Advanced LIGO Engineering Change Request (ECR)

ECR Title: ECR: Add black glass panels to the OMC Suspension Assembly to mitigate stray light noise

DCC No: E1500042-v1

ISO VIEW
(INTERIOR SURFACES BAFFLE ONLY)

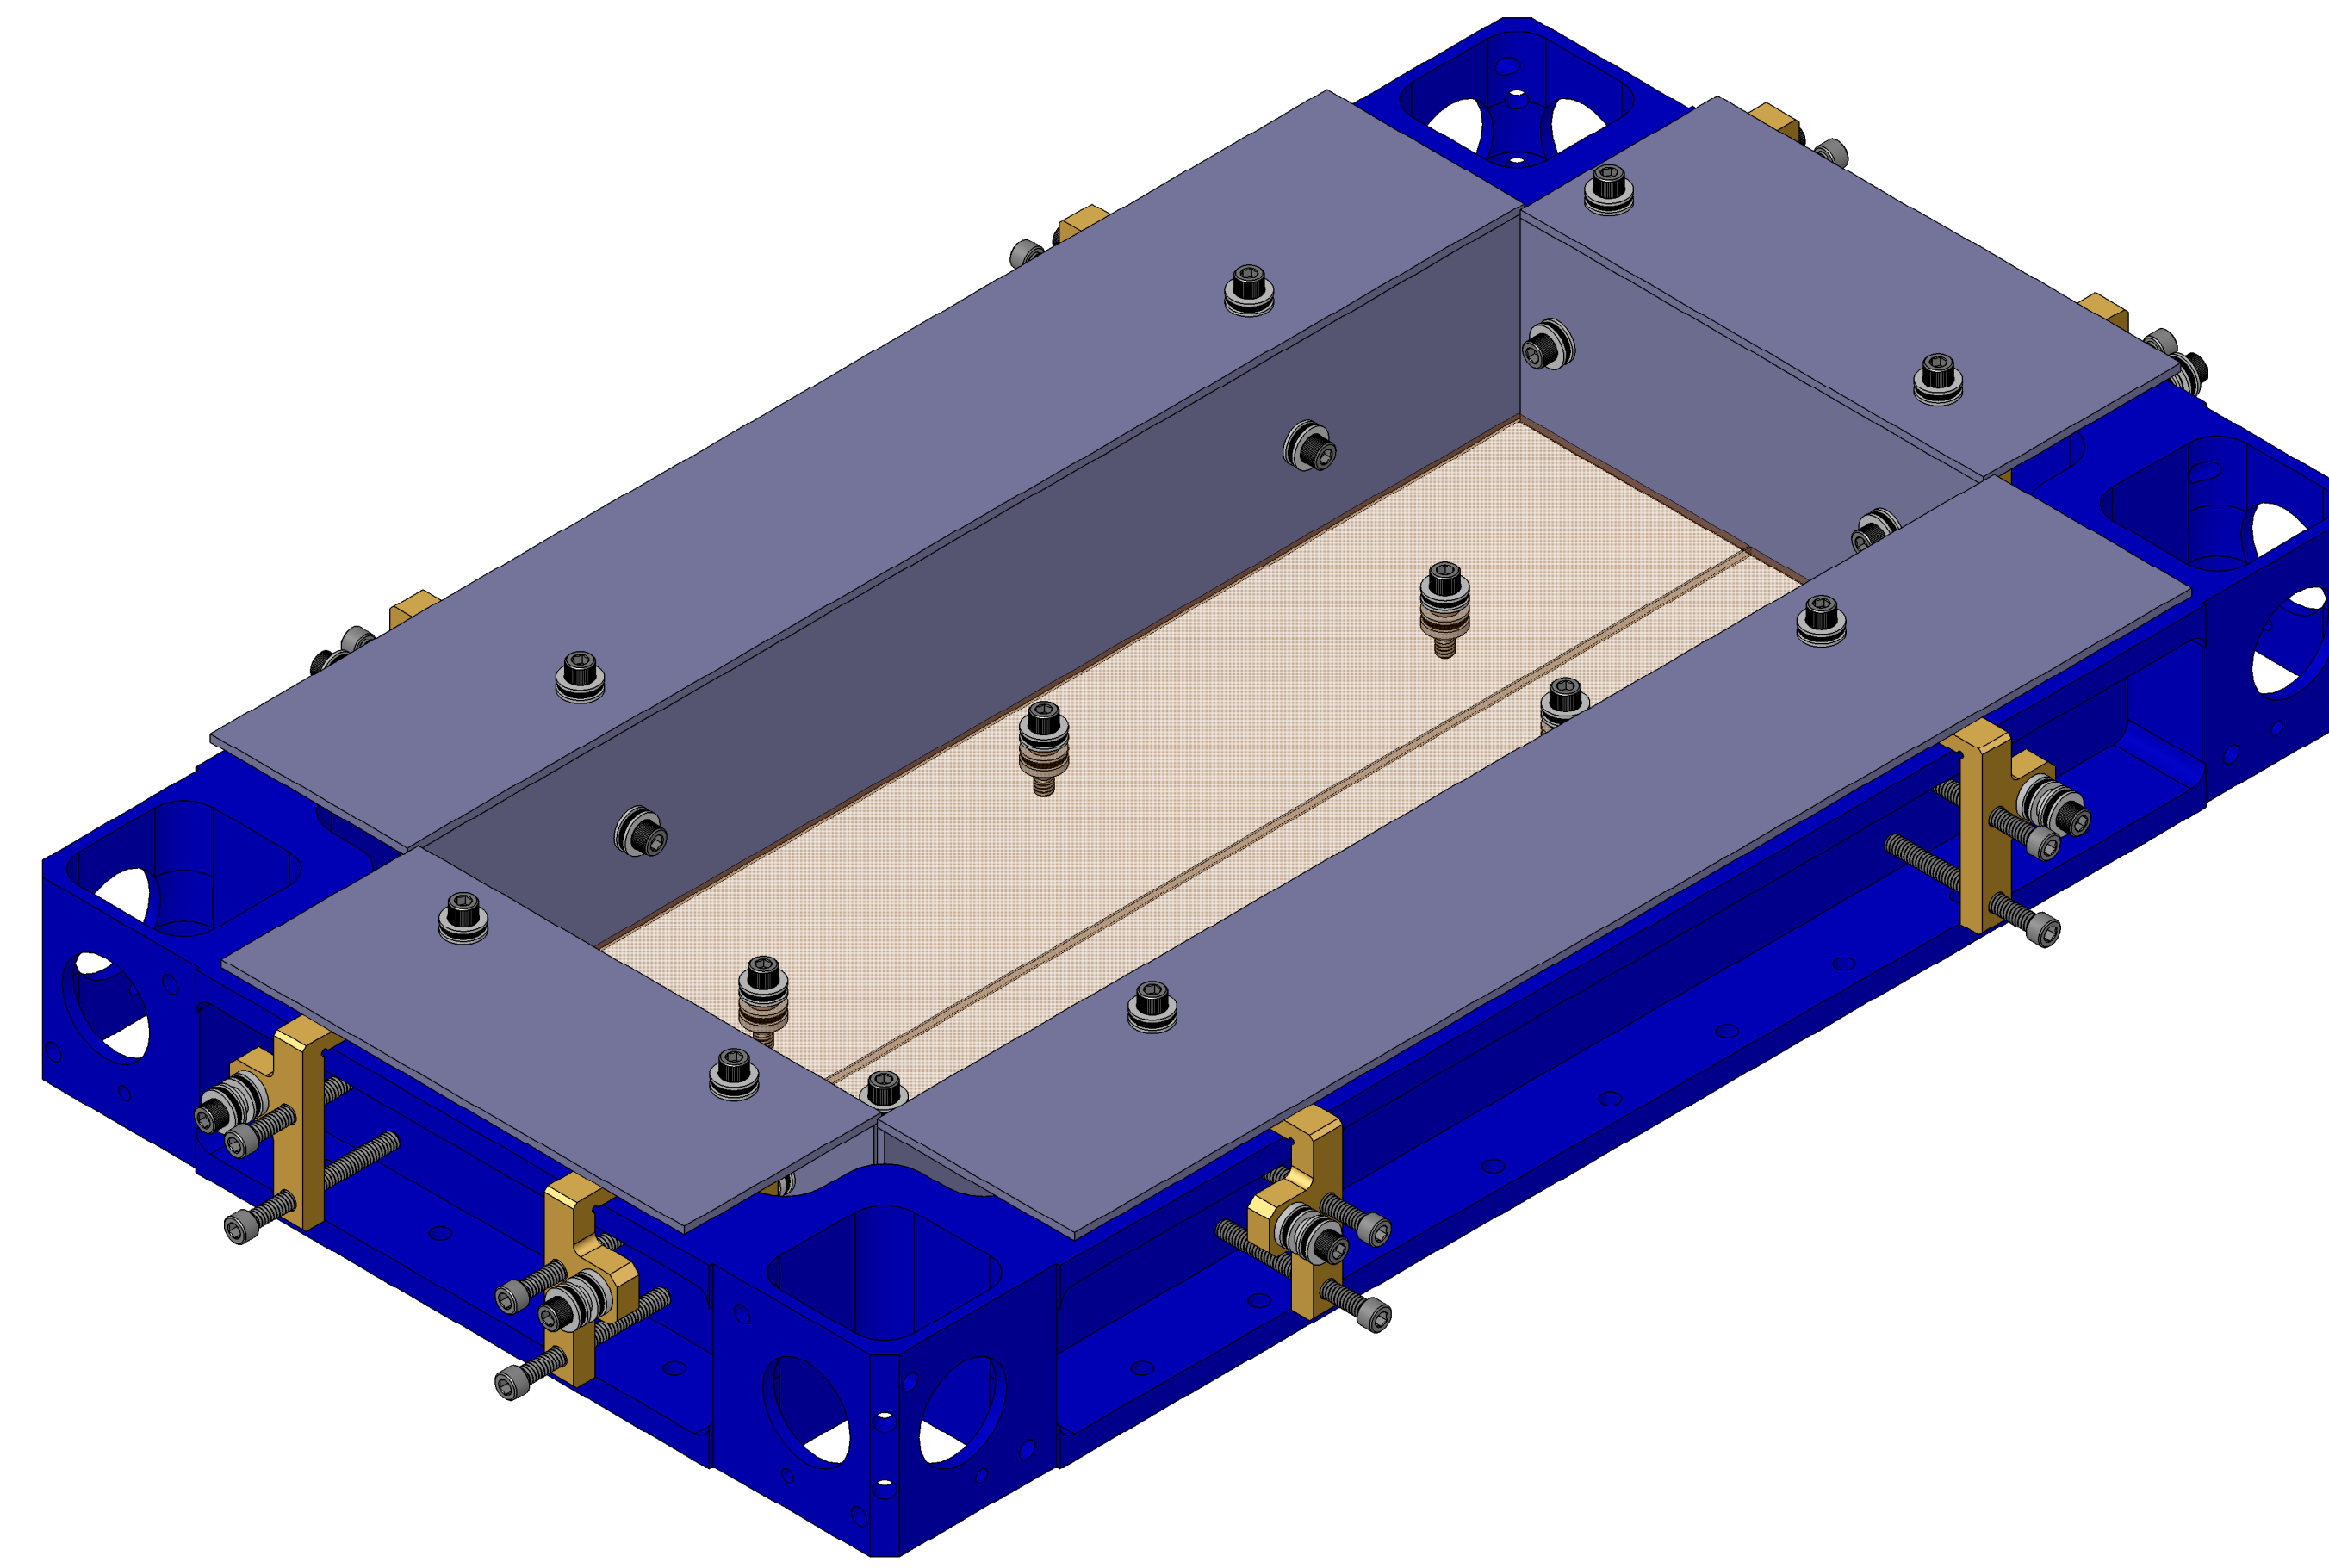
Description of Proposed Change(s): Attach AR-coated black glass panels to the OMC suspension structure (and to the optics table beneath the OMC suspension) in order to surround and isolate the OMC from scattering paths to/from the vacuum enclosure and the reflective metallic surfaces of the optics table and the OMC.

Reason for Change(s): DARM noise has been shown to increase when acoustic noise is increased/generated around the HAM6 chamber, implying a path for scattered light noise to/from the OMC involving the HAM6 vacuum enclosure surfaces (chamber walls, viewports and/or septum plate). It is reported in LLO elog #16255 that our current DARM noise (in the frequency range 70 to 400 Hz) might be limited by scattering from HAM6:

BLK GLASS (TOP)
ATTACHED TO TOP MT. BRACKET
VIA 1/4-20 CAPTIVE SCREW
(SEE HARDWARE STACK-UP DETAIL, FOR REFERENCE)
